**KITTITAS COUNTY JAIL
MECHANICAL REPAIRS**

ADDENDUM NO. 2
March 12, 2010

REFERENCE:
A1.1
DETAIL NO.
ASK-01

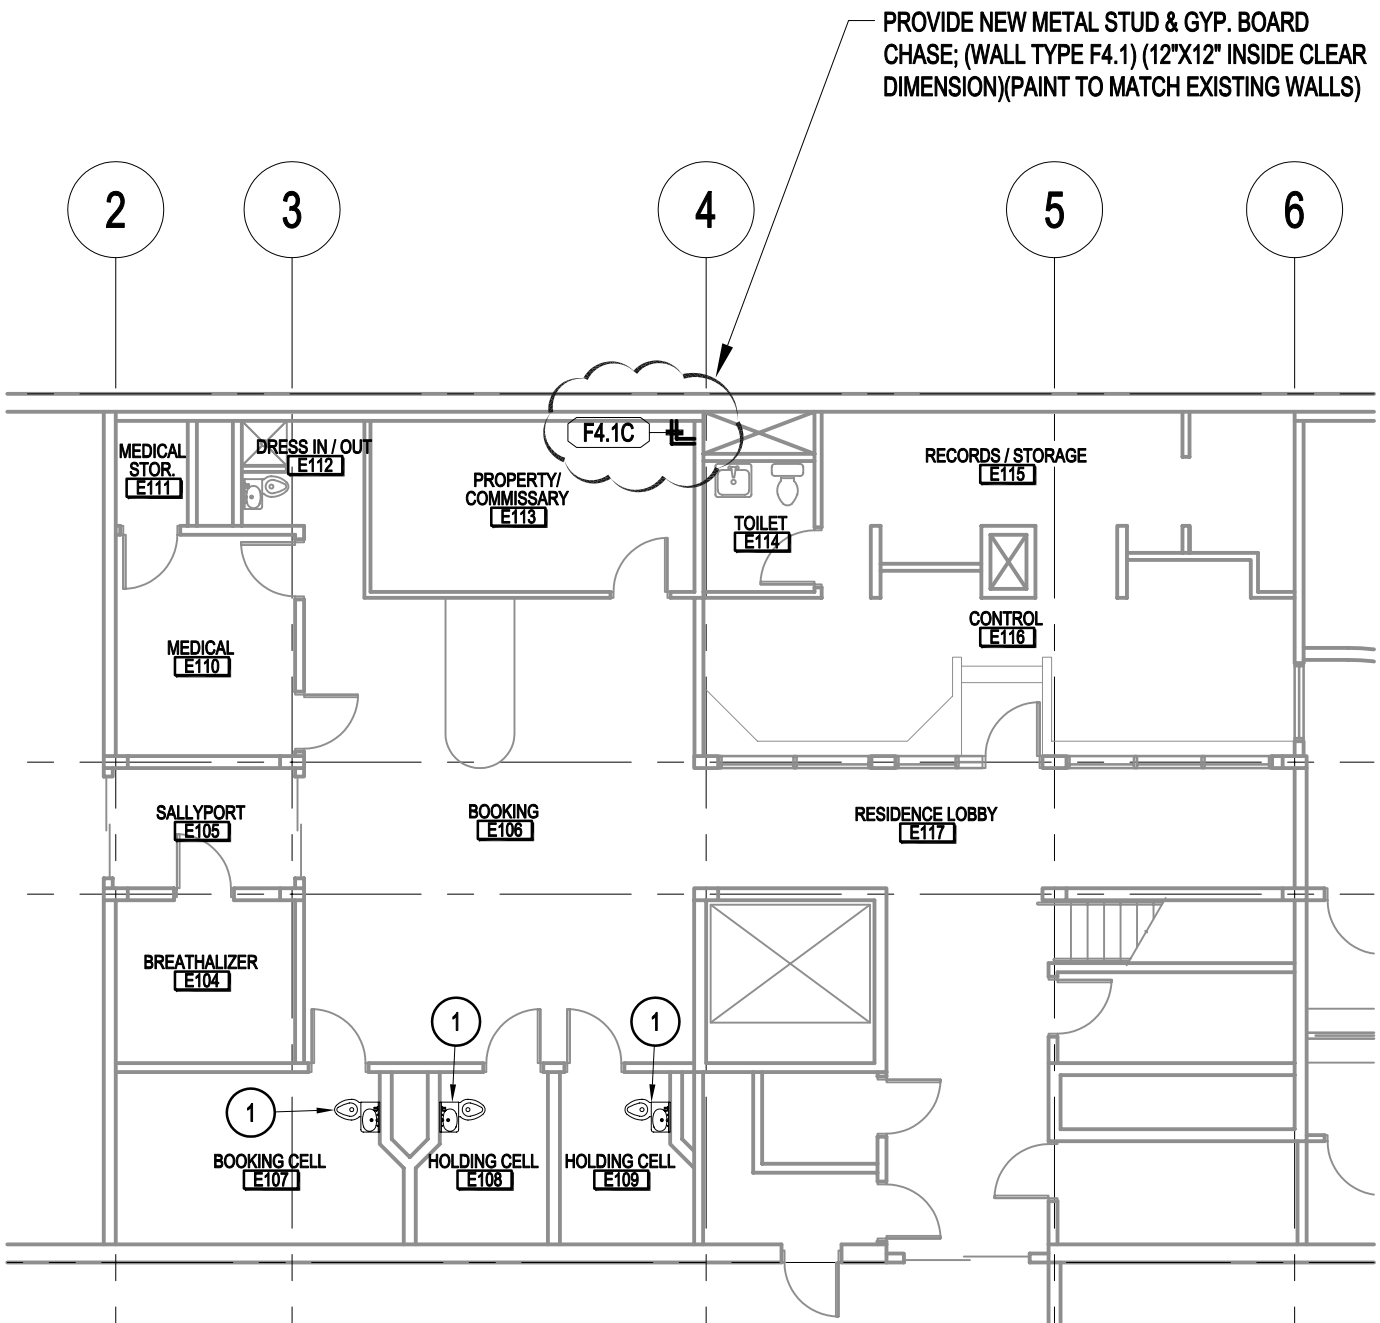
2. Sheet A1.1, **REVISE** partial 1st floor reflected ceiling demolition plan, per attachment ASK #01.
3. Sheet A2.0, **REVISE** partial 1st floor plan per attachment ASK #02.

2 ENLARGED TOILET E006
 SCALE: 1/4" = 1'-0"

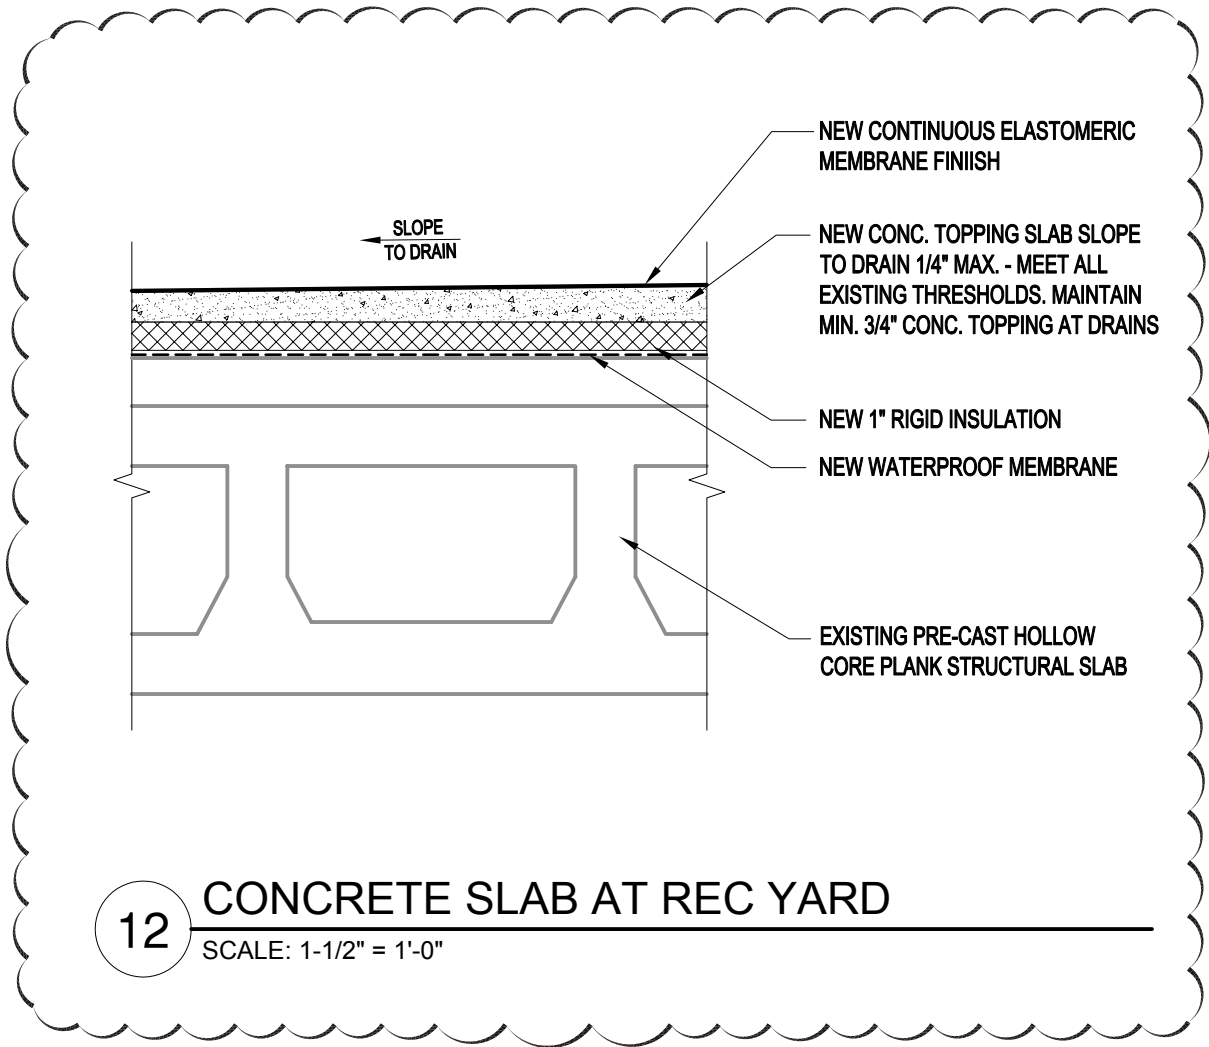
6. Sheet A2.1, **REVISE** enlarged toilet plan E006 per attachment ASK #03
7. Sheet A2.1, **ADD** Keynote #14 to read: “New plumbing fixture as part of alternate bid #2 - refer to mechanical”. Point keynote #14 at Detail 6; to water closet and lav in Toilet/Shower Room E215.

12 CONCRETE SLAB AT REC YARD
 SCALE: 1-1/2" = 1'-0"

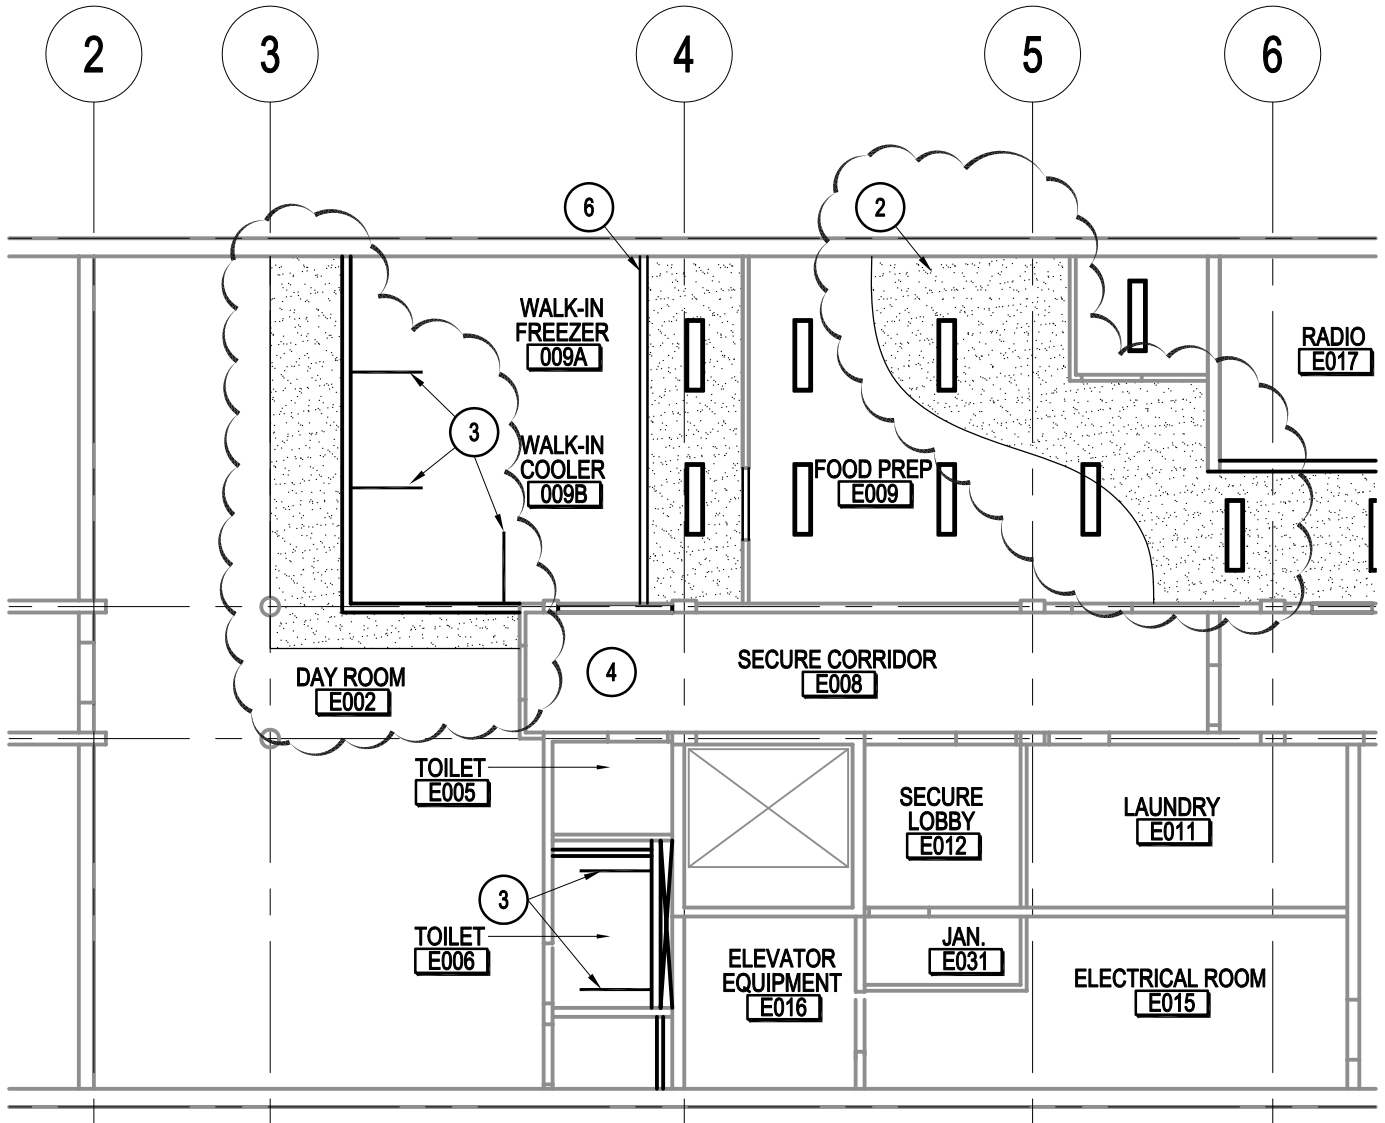
10. Sheet A3.0, **REVISE** Keynote #5 to read: “Provide new glue-on ceiling tile in selected cells and secure areas to match adjacent existing ceiling as directed by Owner. Contractor to inventory all quantity of ceiling tile proposed of each area to be removed & replaced for the new construction work. For bidding purposes, compute approximately 20 square feet of new tile per cell and cell vestibule. Total square footage: 1,000.”
11. Sheet A3.0, **REVISE** partial basement reflected ceiling plan per attachment ASK #05.
12. Sheet A5.0, **DELETE** Plan Details #2 and #3.
13. Sheet A6.0, **ADD** ASK#04 for new concrete floor detail at recreation yards.
